From: Laura Ashelford <lashelford@dvc.tas.gov.au>
Sent: Wednesday, 31 January 2024 12:06 PM
To: TPC Enquiry
Cc: O'Brien, Lauren
Subject: Derwent Valley 2015 - draft amendment PSA-2021-6 - submission of additional information
Attachments: UPDATED Mills Estate Specific Area Plan - Post-lodgement - DVC track changes.pdf; UPDATED Mills Estate Specific Area Plan - Post-lodgement - DVC clean copy.pdf; UPDATED Mills Estate Specific Area Plan - Post-lodgement - DVC clean copy.docx; The Mills - SAP_Bushfire requirements_21 December 2023.pdf; Urbis Response to TPC Directions PSA 2021-6 .pdf; Fw: The Mills - SAP requirements; FW: Derwent Valley Draft Amendment PSA 2021-6. Rezone Lots 5 and 6 - Presentation for Hearing

DERWENT VALLEY INTERIM PLANNING SCHEME 2015 DRAFT AMENDMENT PSA 2021-6 LOTS 5 & 6 POULTERS ROAD, NEW NORFOLK RESPONSE TO TPC DIRECTIONS

F1.0 The Mills Residential Estate Specific Area Plan

Diagram 1.56.1A. Building envelope as required by subclause 1.56.1 A3 (a)

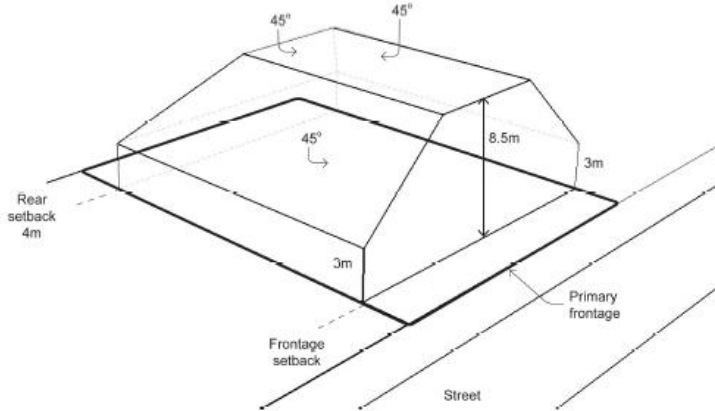
1.56.1 Setbacks and building envelope for all dwellings

<p>(refer to Diagram 1.46.1C) determined by:</p> <ul style="list-style-type: none"> (i) the front boundary; and (ii) a distance of 3 m from the side boundary; and (iii) a building height that does not exceed a plane measured from 8.5 m above existing ground level at the front boundary to 9.5 m above existing ground level at a point 20 m along the side boundary; and (iv) a distance of 4 m from the rear boundary or 25 m from the front boundary, whichever is the lesser. 	
<p>A4</p> <p>A garage or carport for a dwelling must:</p> <ul style="list-style-type: none"> (a) have a setback to a side boundary of at least 1.5 m; and (b) not exceed a total length of 9 m; and (c) have a building height of not more than 3 m above existing ground level measured at the point of the front and side boundaries. 	<p>P4</p> <p>The siting and scale of a garage or carport for a dwelling must:</p> <ul style="list-style-type: none"> (a) not cause unreasonable loss of amenity to adjoining properties, having regard to: <ul style="list-style-type: none"> (i) reduction in sunlight to a habitable room (other than a bedroom) of a dwelling on an adjoining property; or (ii) visual impacts caused by the apparent scale, bulk or proportions of the outbuilding when viewed from an adjoining property.

Figure 1.2 Development Framework

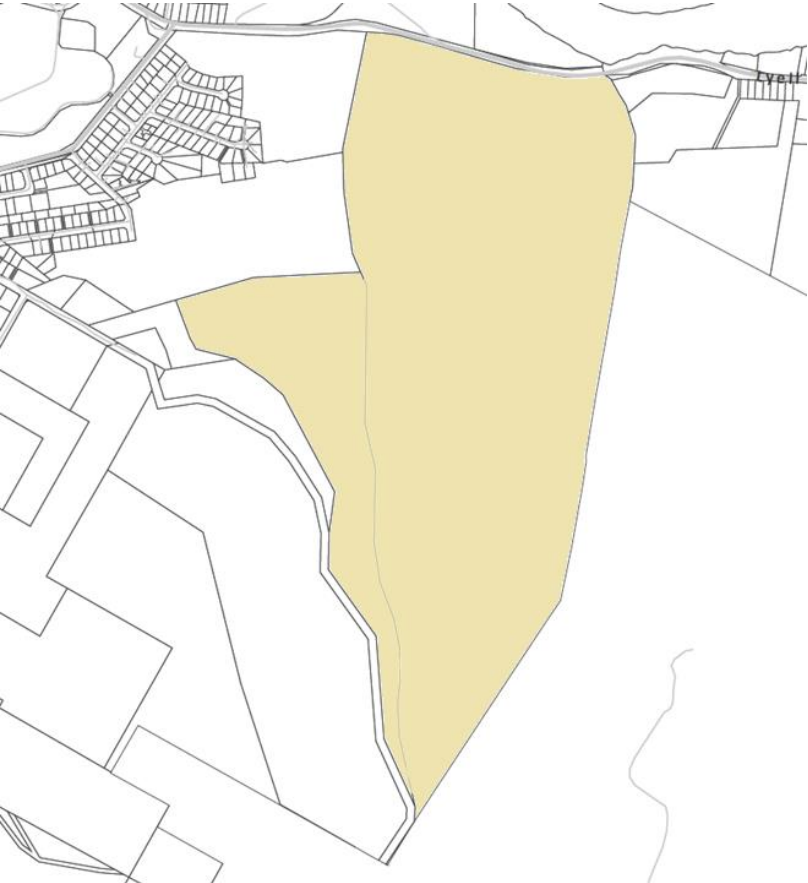
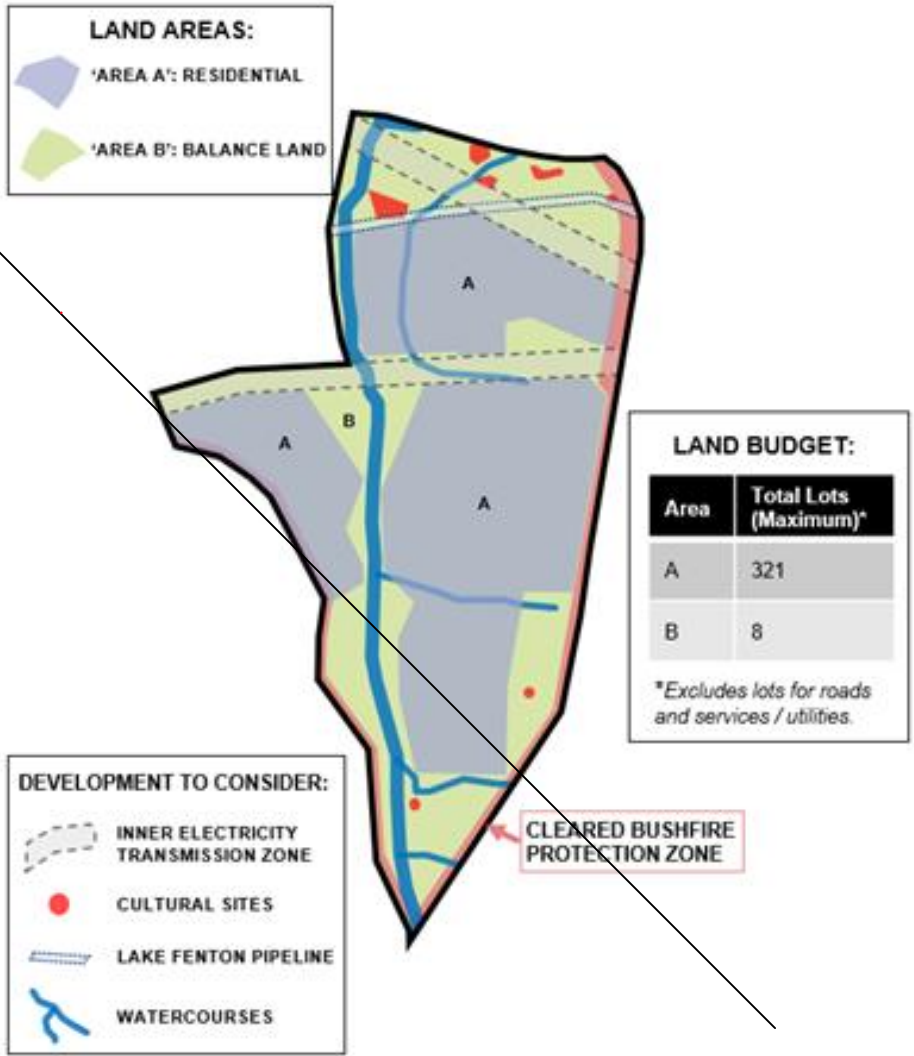
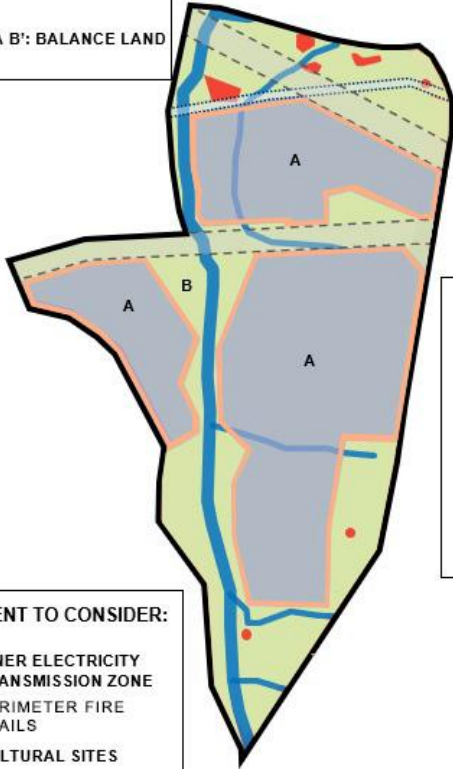
This clause substitutes Clause 10.2 in the General Residential Zone only for the land shown as 'Area B' (Balance land) in Figure 1.2.

<ul style="list-style-type: none"> (a) provision of no more than the maximum lot number specified in Figure 1.2 Land Budget; (b) staging, if any, provides for the efficient and ordered provision of new infrastructure; (c) is consistent with the applicable Desired Future Character Statements within this control.
--	---
